CITY OF NEWPORT BEACH
COMMUNITY DEVELOPMENT DEPARTMENT
BUILDING DIVISION

GRADING/DRAINAGE
PLAN REVIEW COMMENTS

Figure A

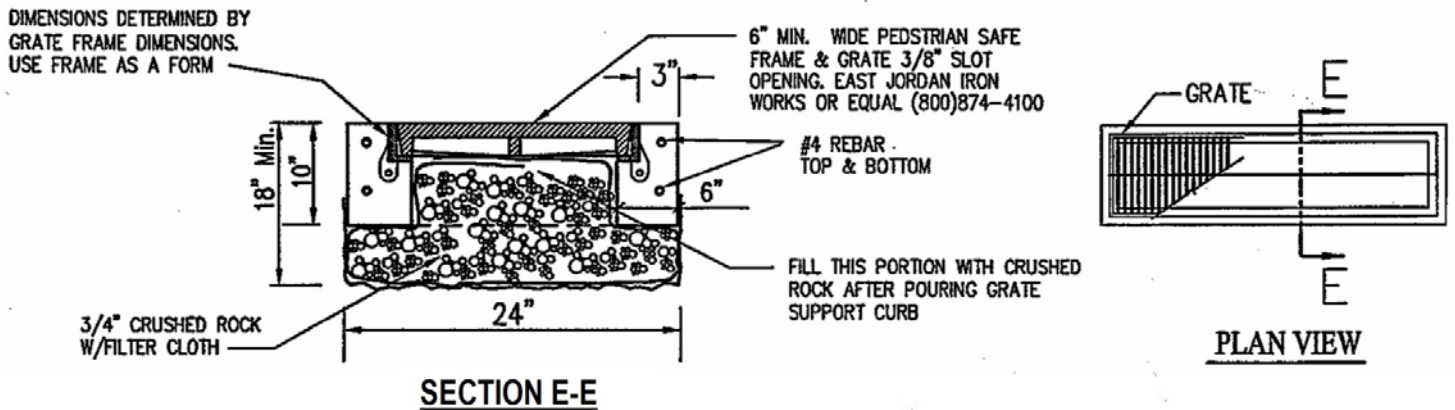
- a. Sheet flow through lawn areas and/or area drains connect to a minimum 15' long French drain in crushed rock bed wrapped with filter cloth as shown in Figure A on last page provided:

39. Provide a trench drain at bottom of driveway as shown in Figure B on last page. (Exception: When driveway is less than 10' long and no other site drainage flows through driveway)

- a- Dig a 24" wide X 18" minimum depth trench
- b- Place filter cloth in the trench. Lap 12" @ top
- c- Fill bottom of the trench with 3/4" crushed rock.
- d- Form and pour perimeter concrete curb.
- e- Fill the rest of the trench with crushed rock to 4" from top of trench.
